Model: Mojito		Date: 14-Apr-00	No.: RA293001
Subject: Software Update for Mail Box CS360		Prepared by: A. Sasaki	
From: Technical Service Dept., GTS Division			
Classification:	<input type="checkbox"/> Troubleshooting <input type="checkbox"/> Part information <input checked="" type="checkbox"/> Action required <input type="checkbox"/> Mechanical <input type="checkbox"/> Electrical <input type="checkbox"/> Service manual revision <input type="checkbox"/> Paper path <input type="checkbox"/> Transmit/receive <input type="checkbox"/> Retrofit information <input type="checkbox"/> Other ()

Model: Mojito		Date: 19-May-00	No.: RA293002
Subject: LG kit (8 1/2"x14"paper size tray Installation procedure and parts catalog		Prepared by: F. Noguchi	
From: Technical Service Dept., GTS Division			
Classification:	<input type="checkbox"/> Troubleshooting <input type="checkbox"/> Mechanical <input type="checkbox"/> Paper path <input type="checkbox"/> Other ()	<input type="checkbox"/> Part information <input type="checkbox"/> Electrical <input type="checkbox"/> Transmit/receive	<input type="checkbox"/> Action required <input checked="" type="checkbox"/> Service manual revision <input type="checkbox"

No.: RA293009b

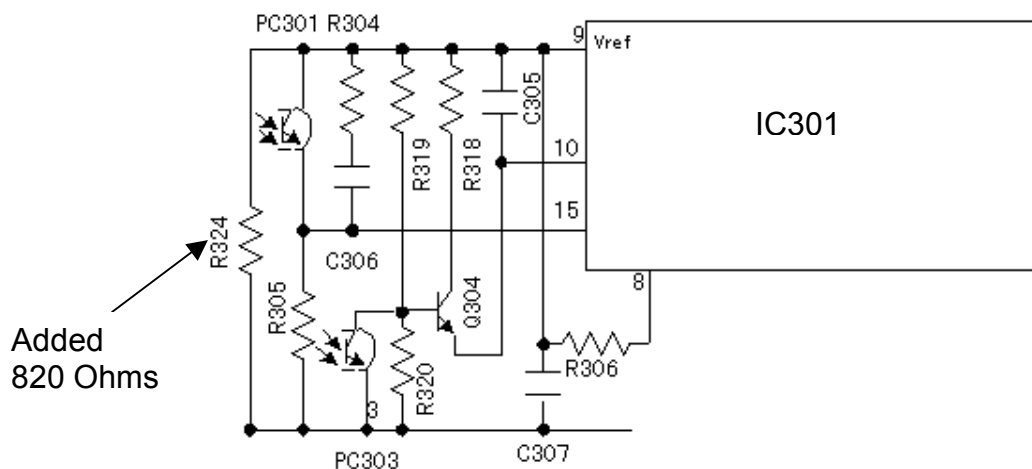
Note: The PSU boards themselves cannot be modified in the field. Therefore, all PSUs now in service parts stock are either modified units or previous units that were found to have no problems (see below for details). The part number for the PSU has not been changed.

An 820 Ohm (1/4w) resistor has been added to the PSU board. In order to do this, the board pattern was changed.

Application Procedure for Drum Setting Powder

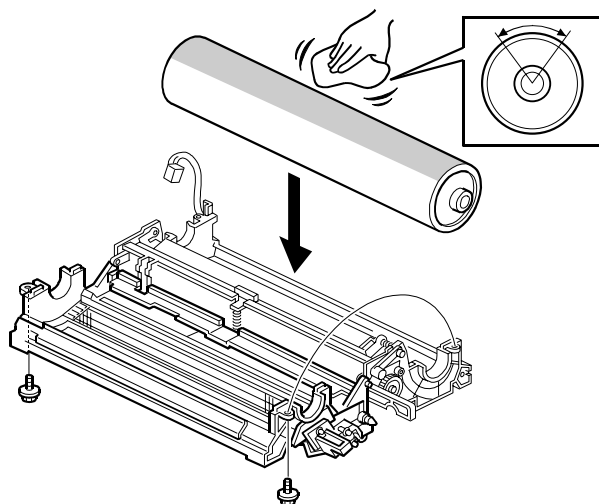
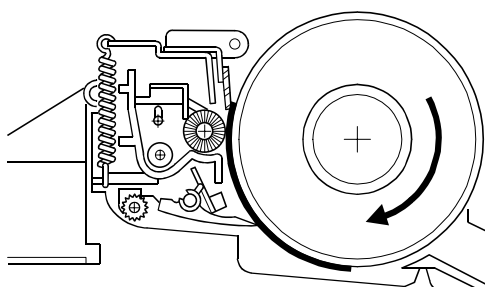
Since the smoothness of the new drum (without dichloromethane) is reduced, it is essential to **make sure and apply Drum Setting Powder (P/N: 54429101) to the drum surface as shown below before installing.**

Note: If the setting powder is not applied, the drum's cleaning blade may turn outward, causing a drum cleaning failure.

3. Rotate the drum once along its normal rotational direction (arrow shown below), so that it stops again at the same position.
